PROPOSED OUTBUILDINGS for
COTTAGE TO BE BUILT
on REM. Sub 5 of Sub X of Lot 0
Richmond 929
KLOOF FALLS RD

APPROVED

TOWN ENGINEER'S DEPT.

KLOOF TOWN BOARD

PLAN

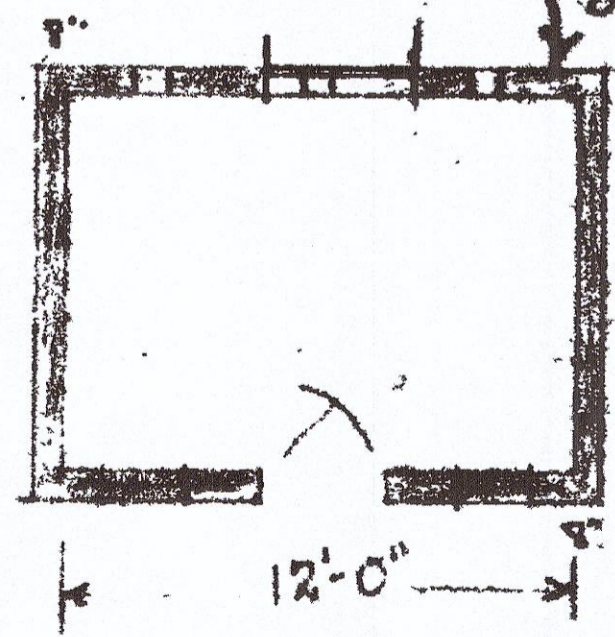
CHANGE POSITIONS OF WINDOWS AS INDICATED IN ORDER TO ENSURE CROSS-VENTILATION
